Planning Commission Staff Report

Meeting Date: May 09, 2024

Petition: **P.Z. 02-2024 18009 and 18045 N. Outer 40 Rd. (Gumbo Flats Properties, LLC)**: A request for an ordinance amendment to create a new “PI” Planned Industrial District for two parcels zoned “M3” Planned Industrial District, “NU” Non-Urban District and “PI” Planned Industrial District, and totaling 78.07 acres located on the north side of Outer 40 Road (16W310045 and 16W240041)

Sheet Title:	Gravel Parking Lot Landscape Plan
Sheet No.:	L1.02
Date:	1/25/24
Job #:	813.127

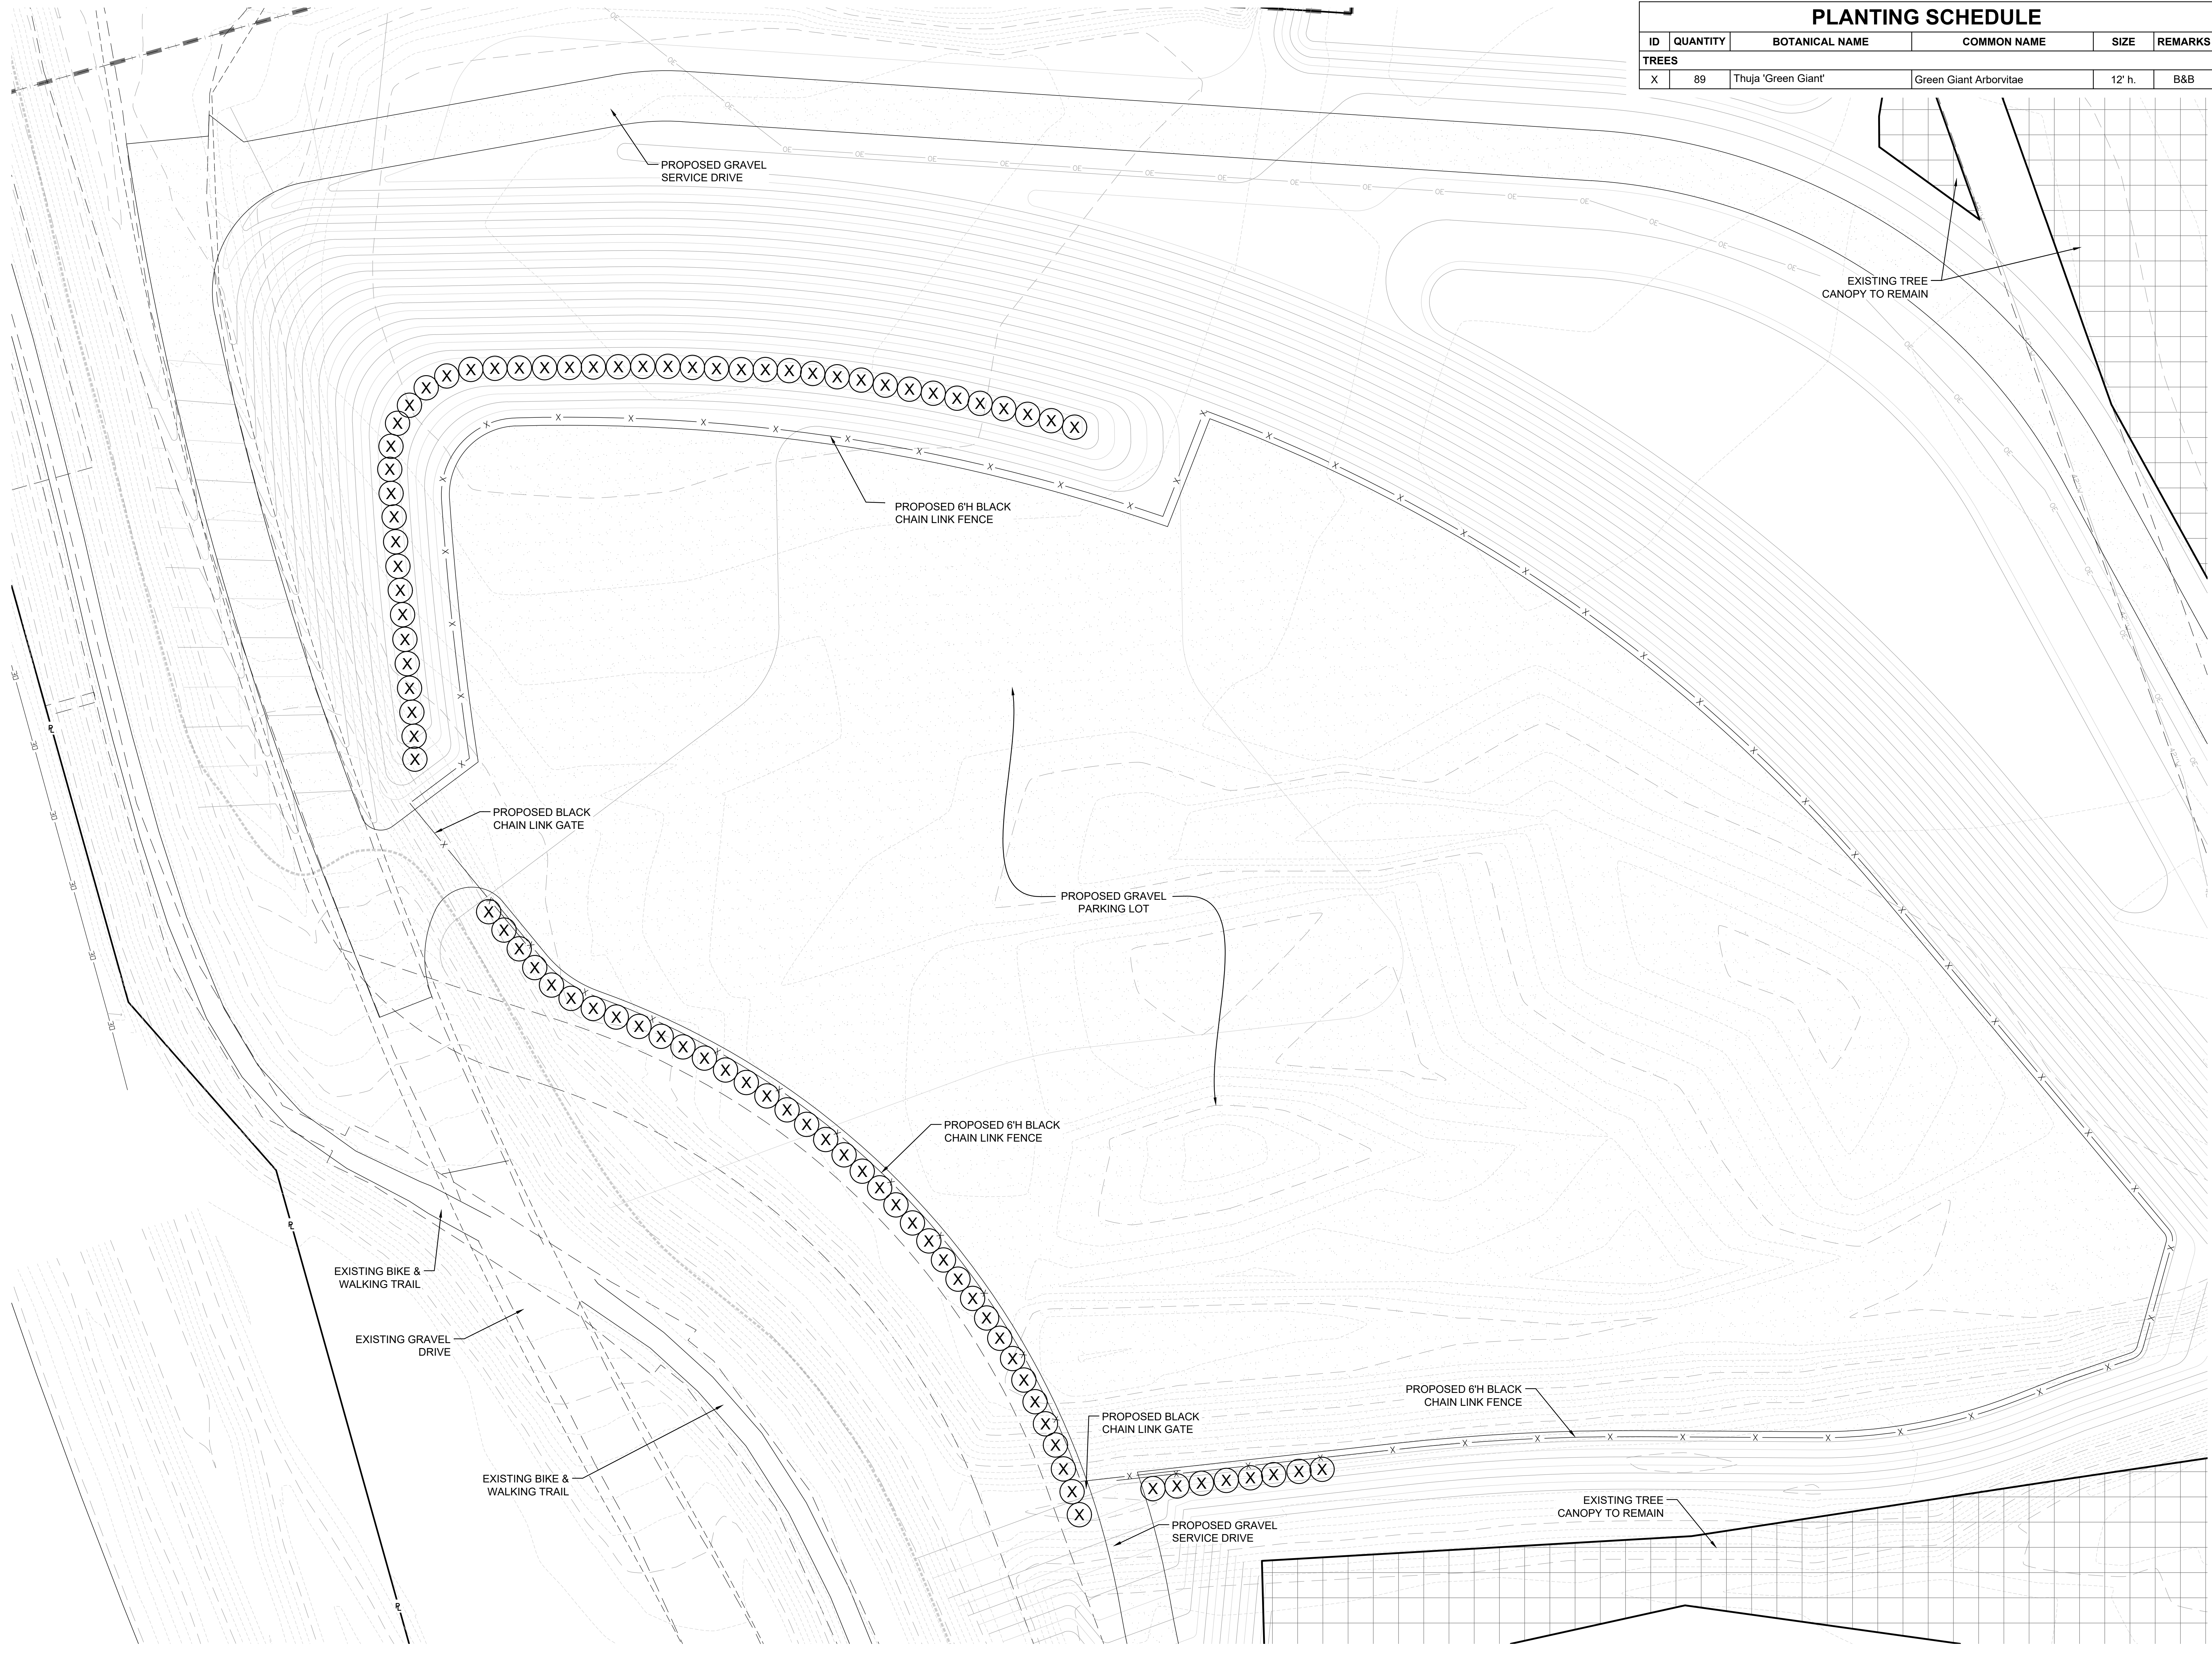
1. Concerns were raised regarding the visual impact of the proposed parking area. Provide information on how the development team will be addressing this concern.

Response: Enclosed are architectural renderings/perspectives from the North and the South. These depict the proposed perimeter landscaping around the perimeter of the parking area and the elevation of the parking area as seen from the highway entering and exiting the City. The parking area is constructed 6'-8' below the top of the levee trail and not visible from westbound I-64. We have added a landscape berm and perimeter landscaping to further shield the view from eastbound I-64.

VIEW WESTBOUND FROM I-64

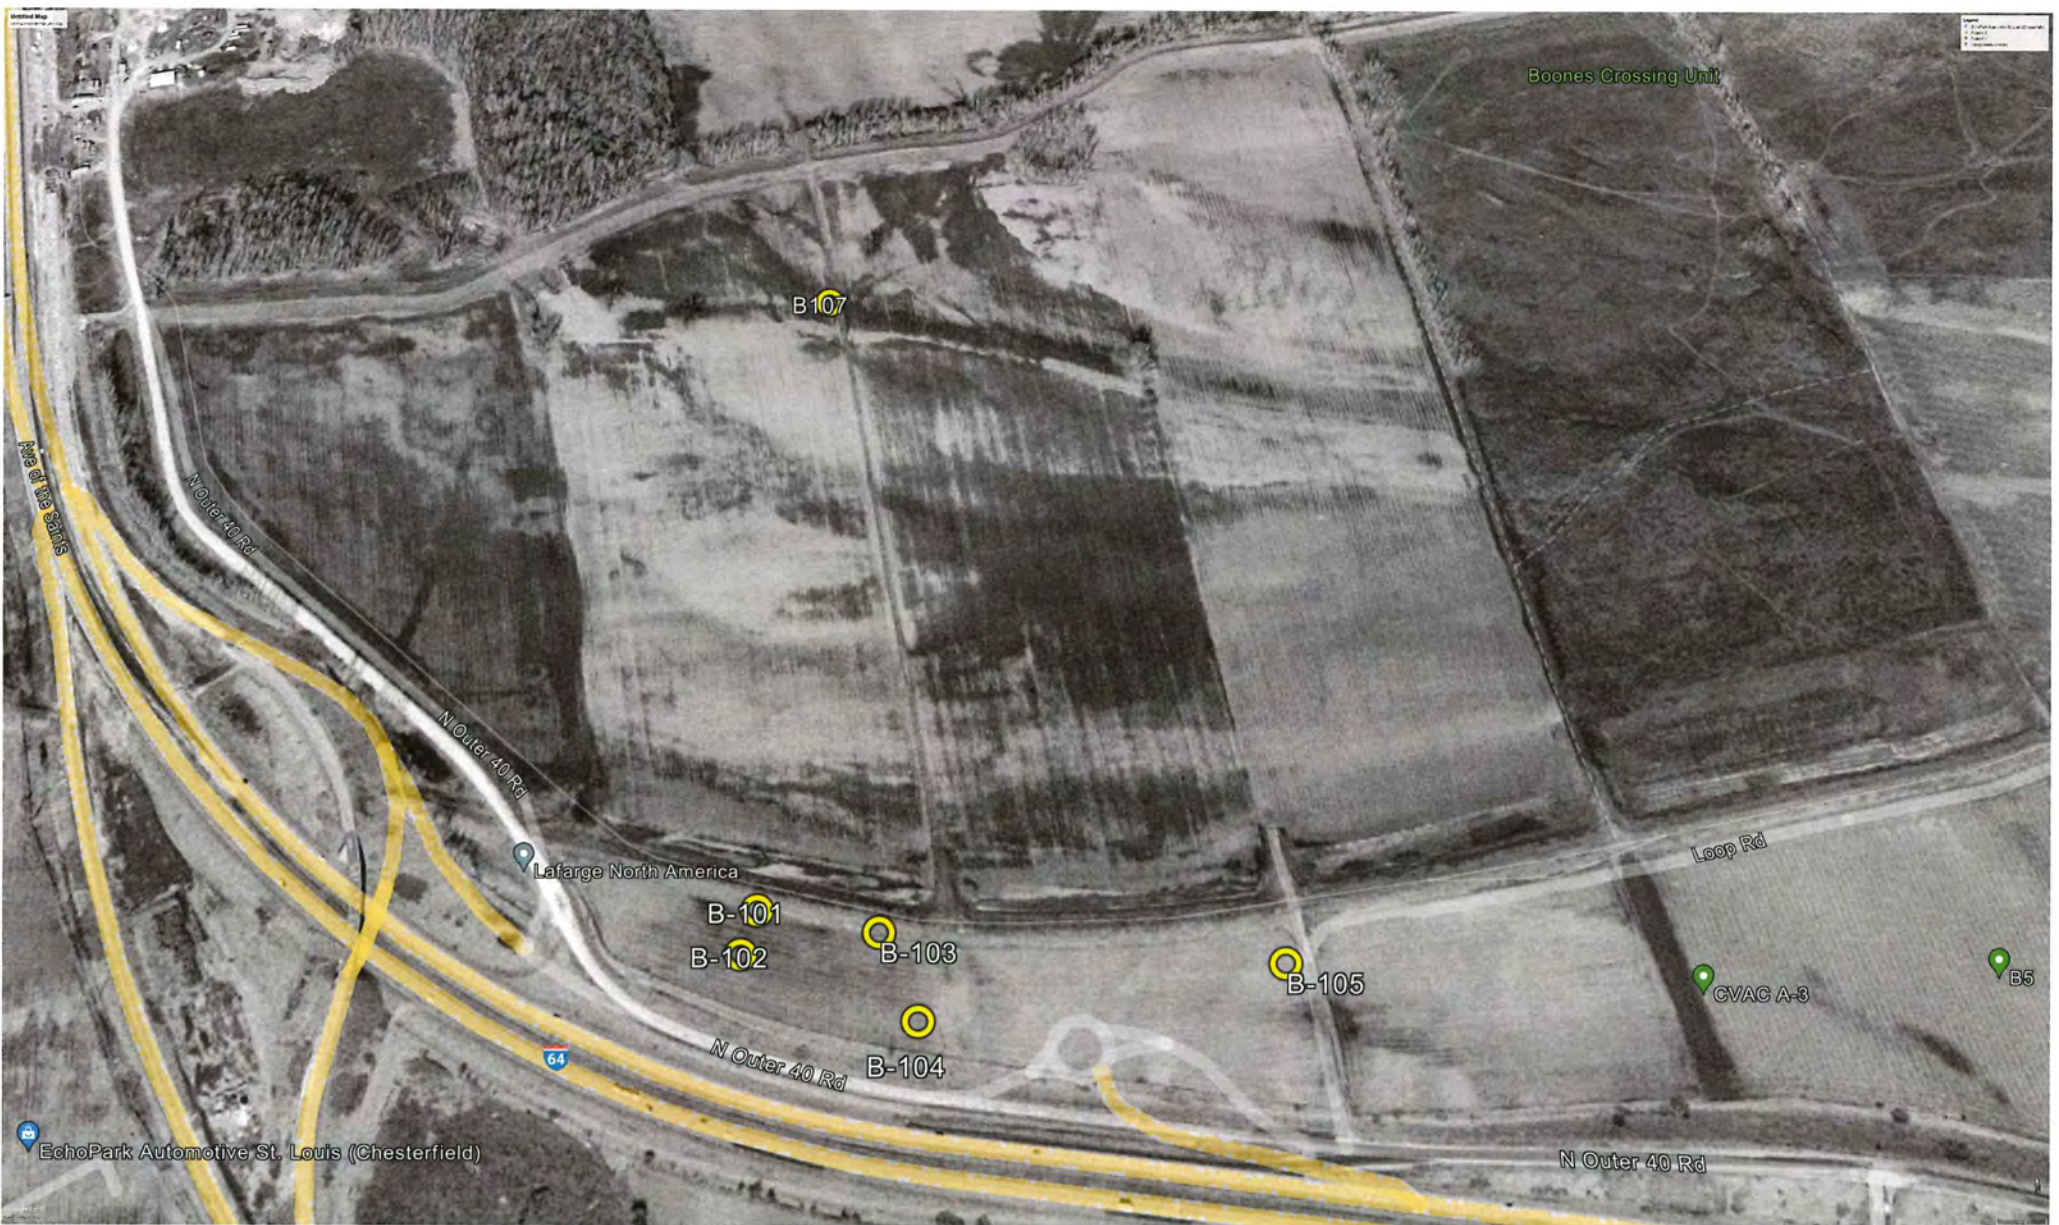
Concerns were raised regarding the visual impact of the proposed parking area. Provide information on how the development team will be addressing this concern.

Response: Applicant provided architectural renderings/perspectives from the north and the south. These depict the proposed perimeter landscaping around the perimeter of the parking area and the elevation of the parking area as seen from the highway entering and exiting the City. The parking area is constructed 6'-8' below the top of the levee trail and not visible from westbound I-64. Applicant has added a landscape berm and perimeter landscaping to further shield the view from eastbound I-64.
